ADDENDUM NO. 1

REPLACE AUTOMATIC TRANSFER SWITCHES
LIHUE AIRPORT
LIHUE, KAUAI, HAWAII
PROJECT NO. CK1422-33

RESPONSES TO REQUEST FOR INFORMATION (RFI'S/QUESTIONS)

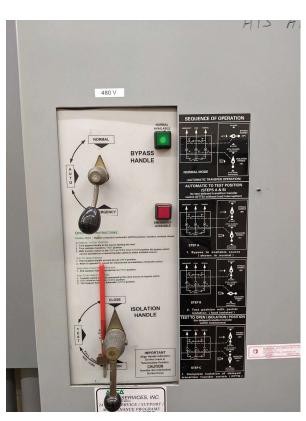
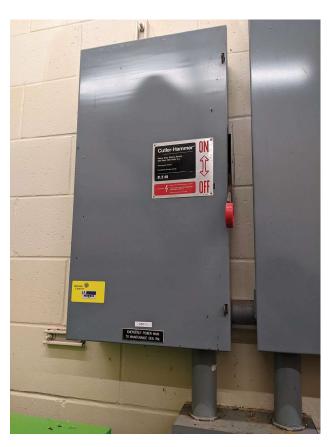
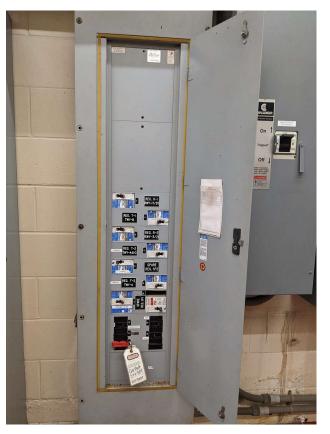
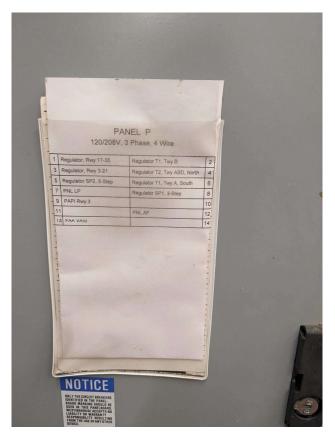
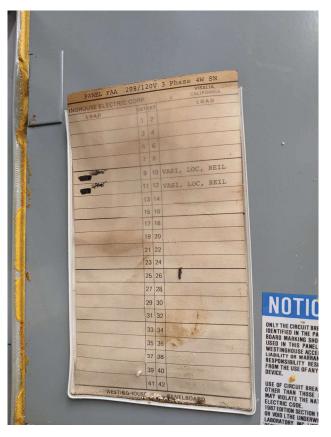
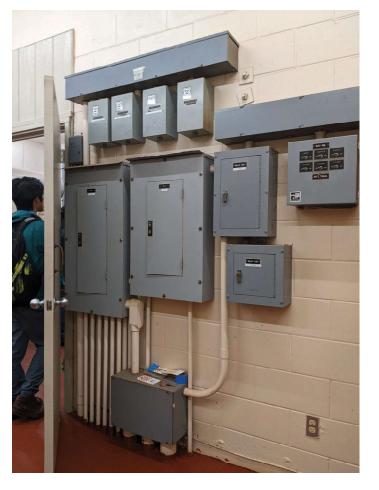
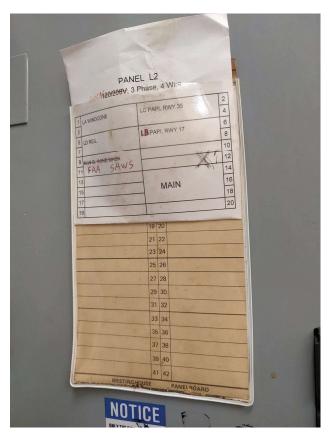
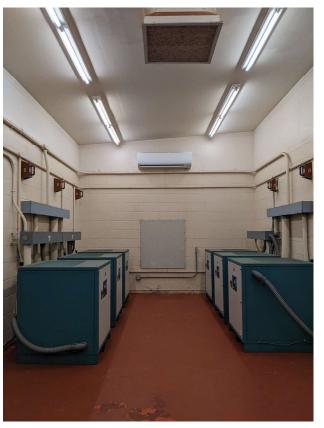
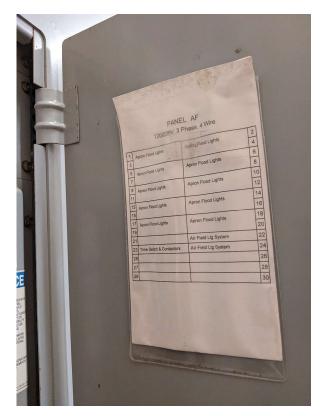
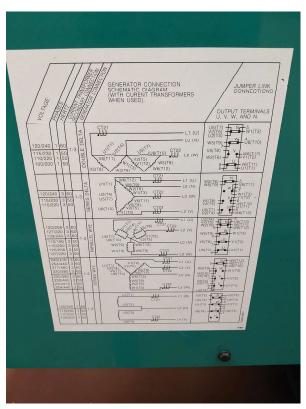
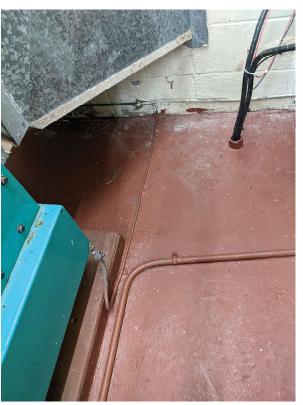
2. **QUESTION**: Would it be possible to ask for existing photo/s of the ATS & interior of the generator room?

RESPONSE: Existing photos are provided on following pages.
